#### **CITY OF CANTERBURY BANKSTOWN**

### **CANTERBURY BANKSTOWN LOCAL PLANNING PANEL MEETING**

#### **ON MONDAY 30 SEPTEMBER 2019**

# Planning Proposal: 74 Rickard Road and Part 375 Chapel Road, Bankstown

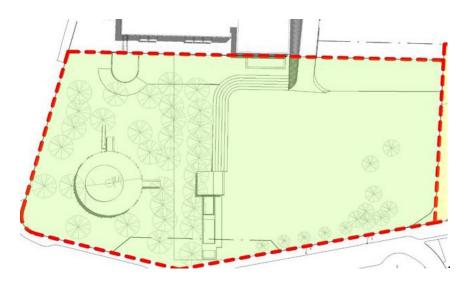
In relation to solar access/overshadowing control the Panel agrees with the suggested control as follows:

- Development must allow for 4 hours of continuous solar access to a consolidated area of Paul Keating Park between 10am and 3pm on 21 June (inclusive of existing shadow). The size of the consolidated area must be a minimum 50% of the area of Paul Keating Park (not including the footprint of existing buildings including the Council chambers).
- The consolidated area means one continuous area of land to prevent the 50% being made up from a number of non-contiguous areas and the area for the 50% calculation is the area shown in the red dotted area (which excludes the Appian Way).
